Our reference: ECM 9126725
Contact: Gavin Cherry
Telephone: (02) 4732 8125

Re: Response to Notification of Modification Application SSD 7173 MOD 8 – Altis Warehouse and Logistics Hub

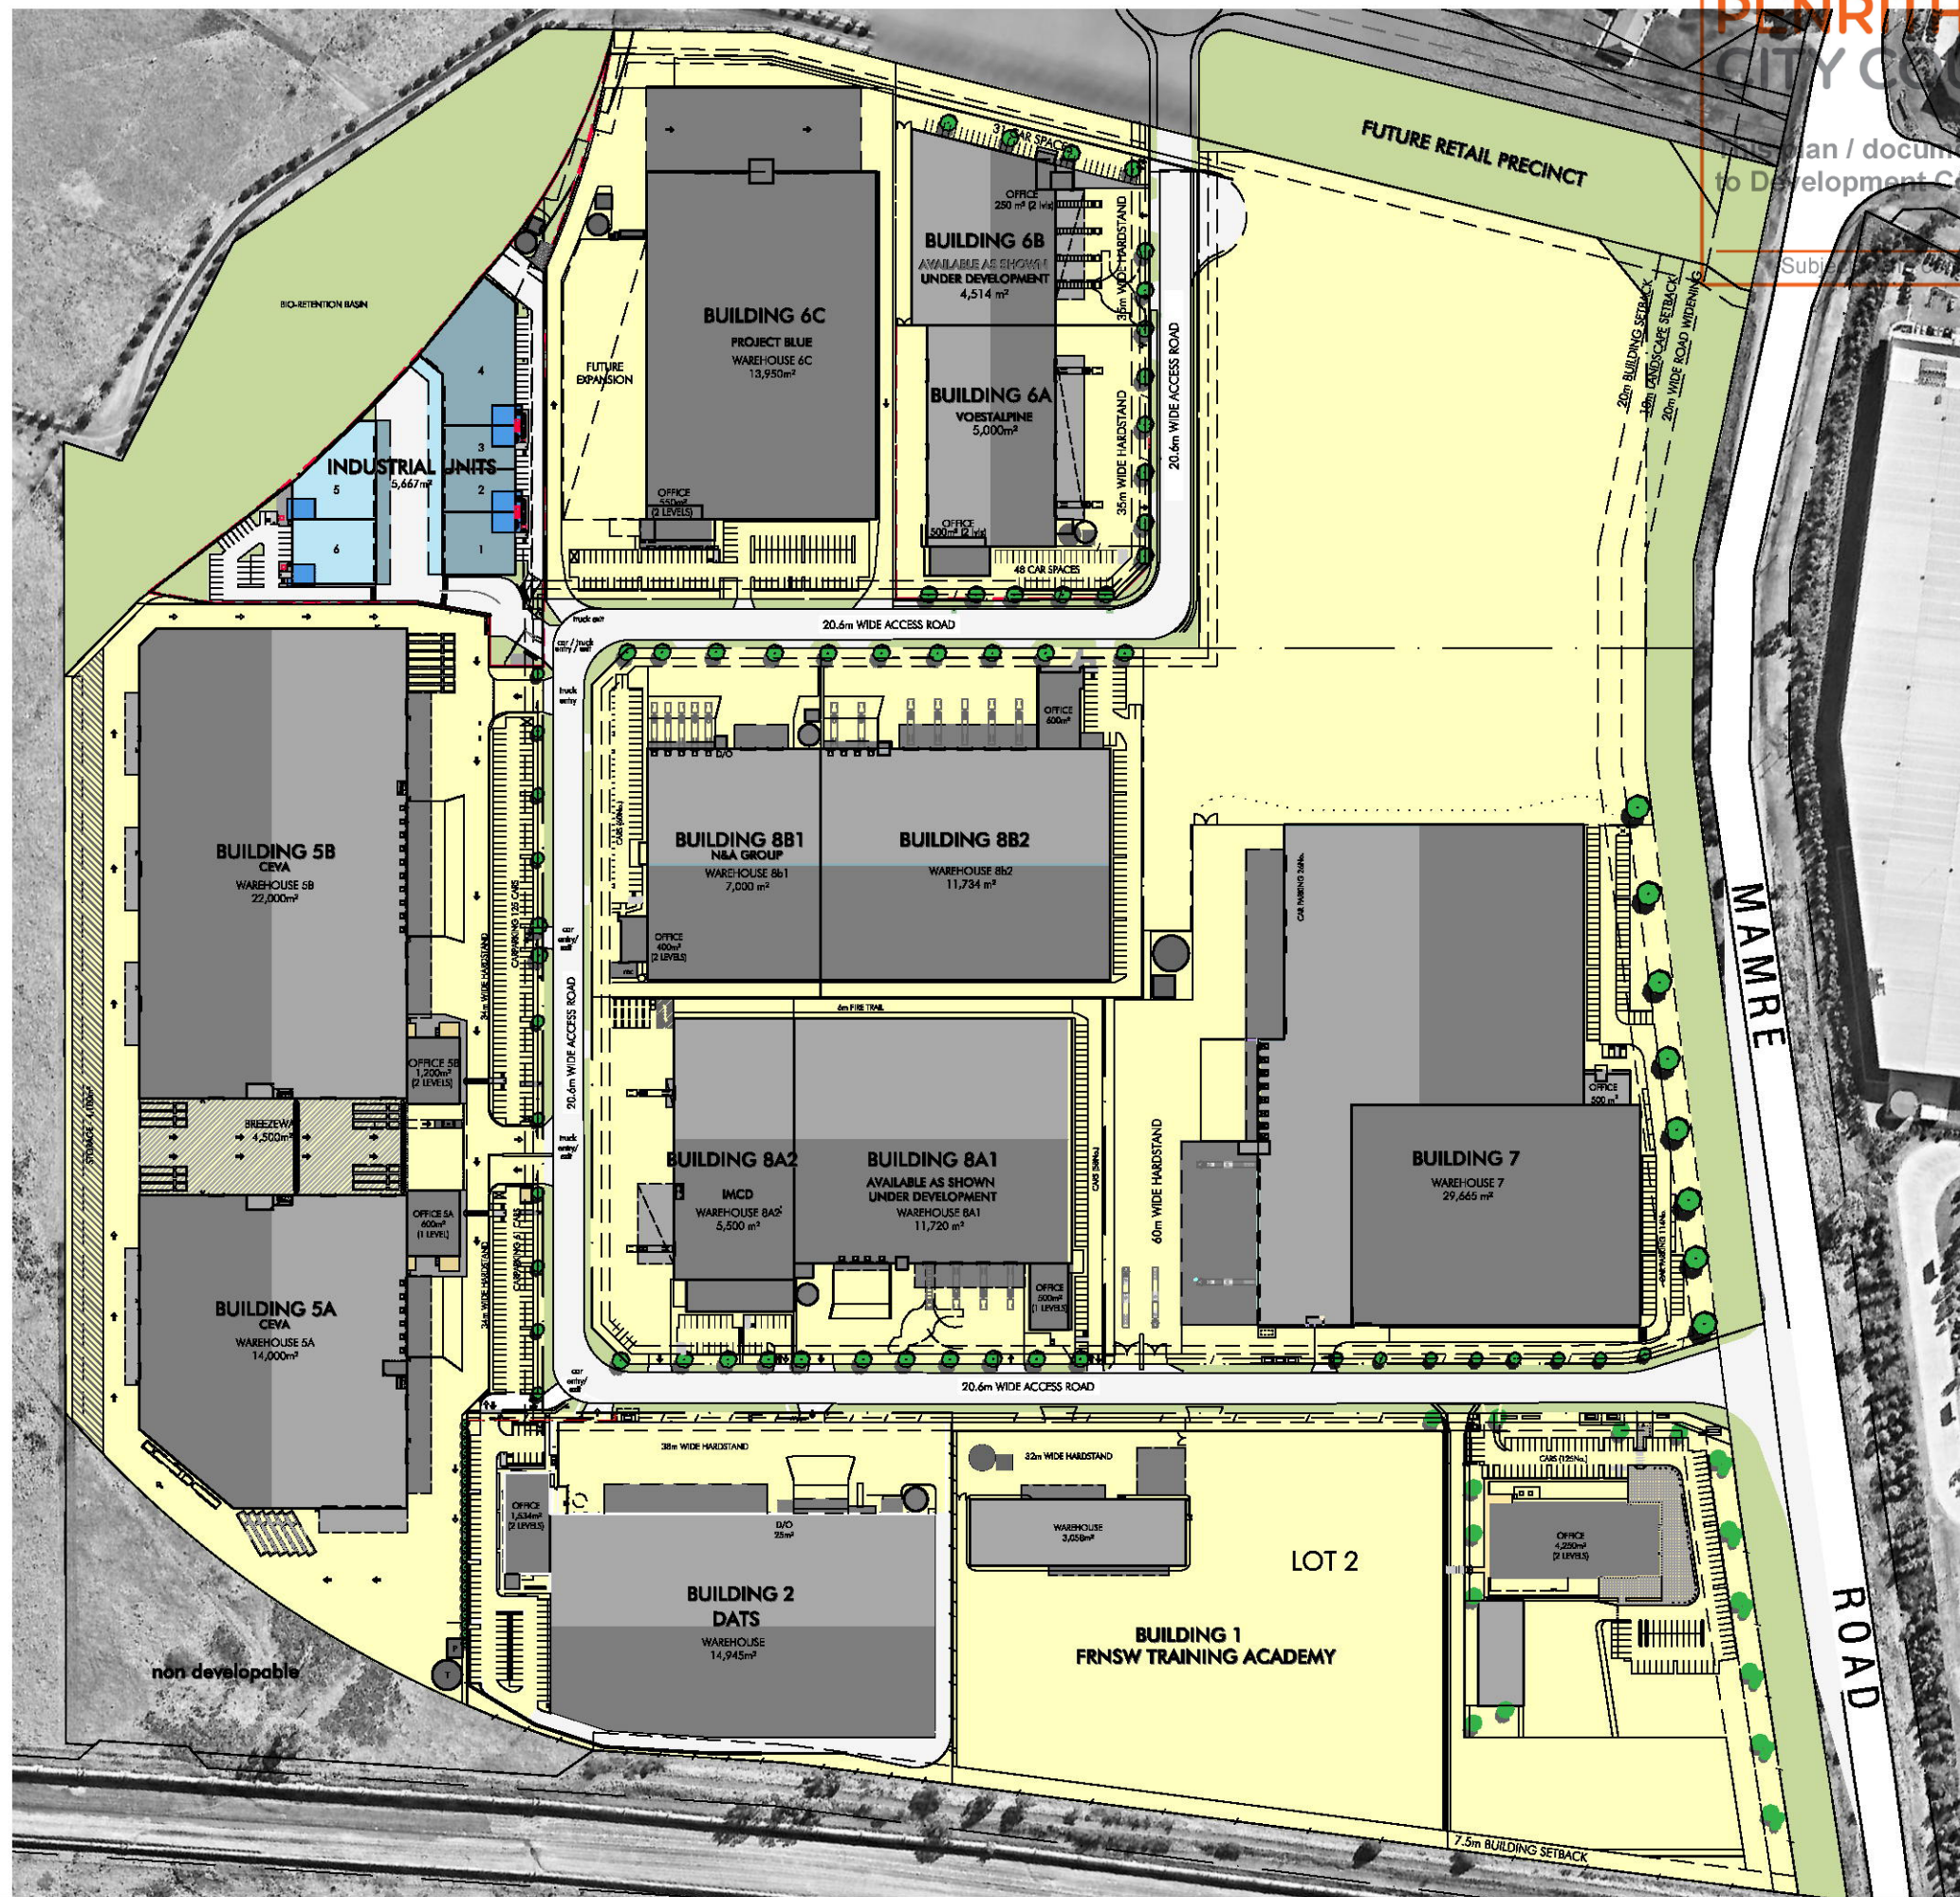
The indicated dividing boundary between Proposed Lot 17 and 18 is depicted within the SSD Mod 8 as a straight alignment. However, DA19/0897 as approved does not set up a straight regular boundary alignment and this is required to ensure clearances of the approved driveways to each development. Refer to the stamped approved plans attached to this letter.

The proposed plan of subdivision should be amended to reflect the allotment / lease boundaries established within DA19/0897, as the current boundary dissects the perimeter driveway for the built form on Proposed Lot 18 which is not appropriate. The proposed plan of subdivision and dividing boundary between Proposed Lot 17 and Lot 18 must be consistent with the boundaries established within DA19/0897 and clear of works approved. The stamped approved Site Plan best reflects the required boundary dimensions and allotment shape for Proposed Lots 17 and 18.

Title
Scale
Date
Number

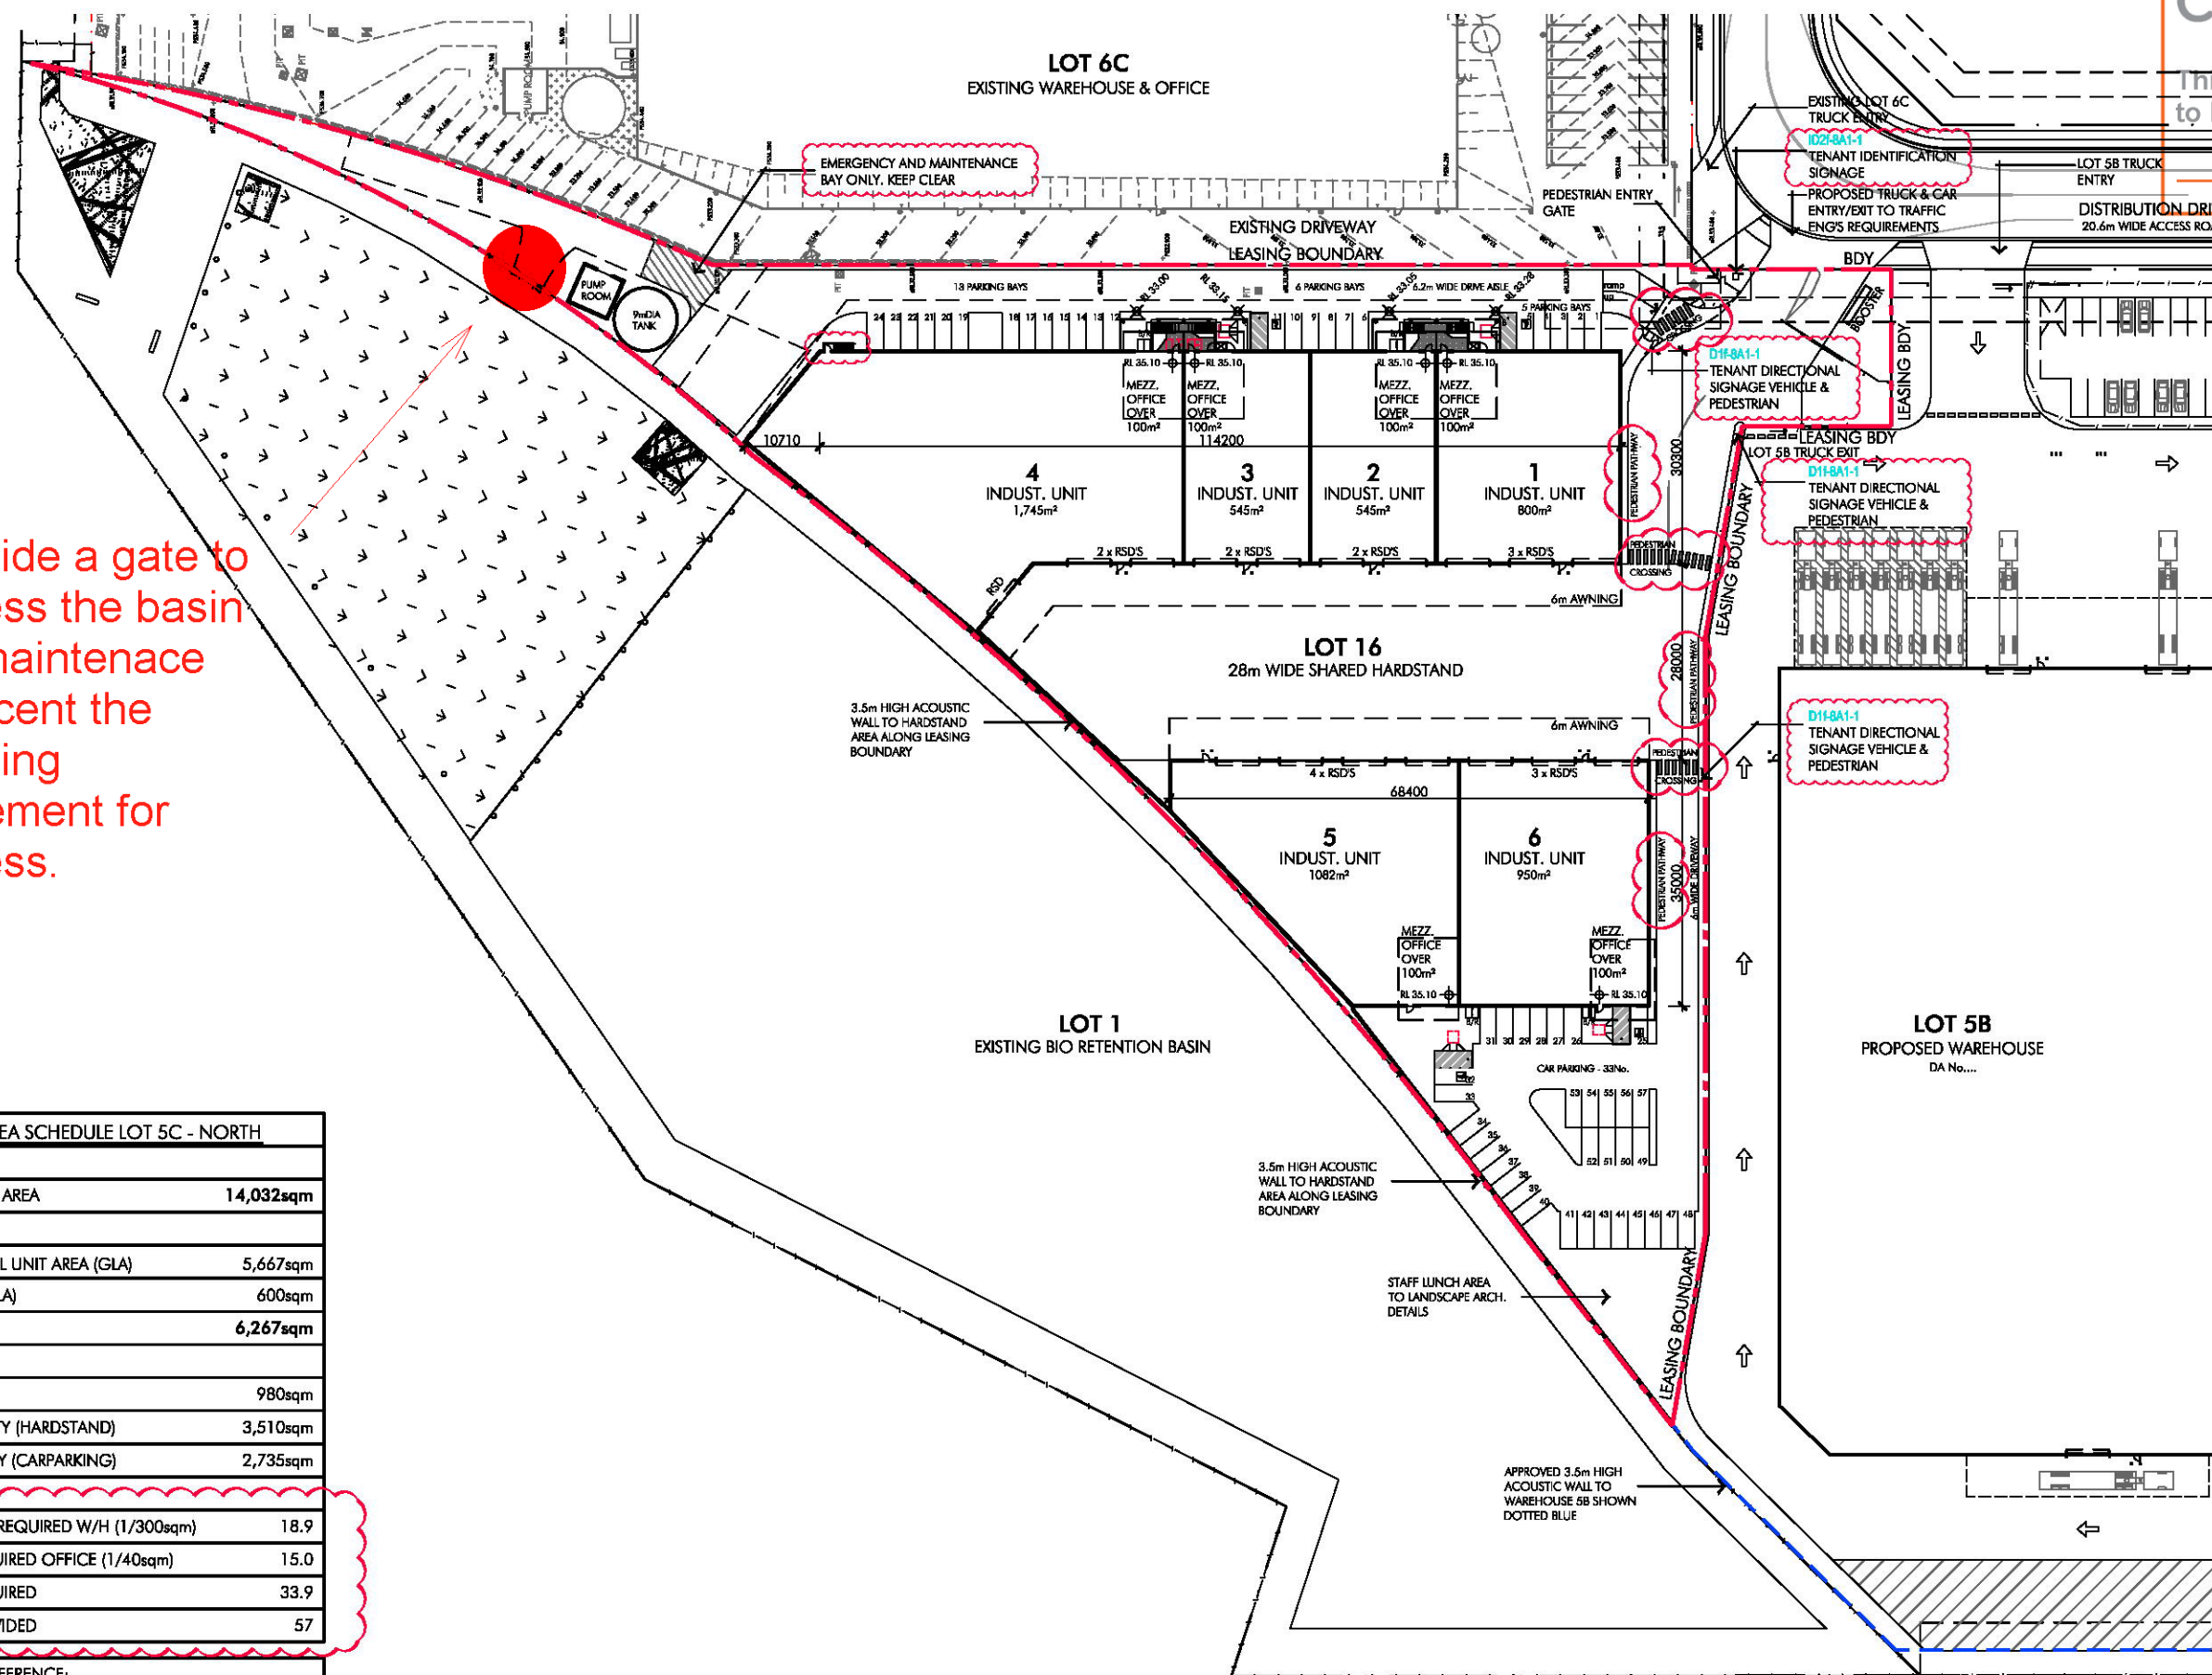
Provide a gate to access the basin for maintenance adjacent the existing easement for access.
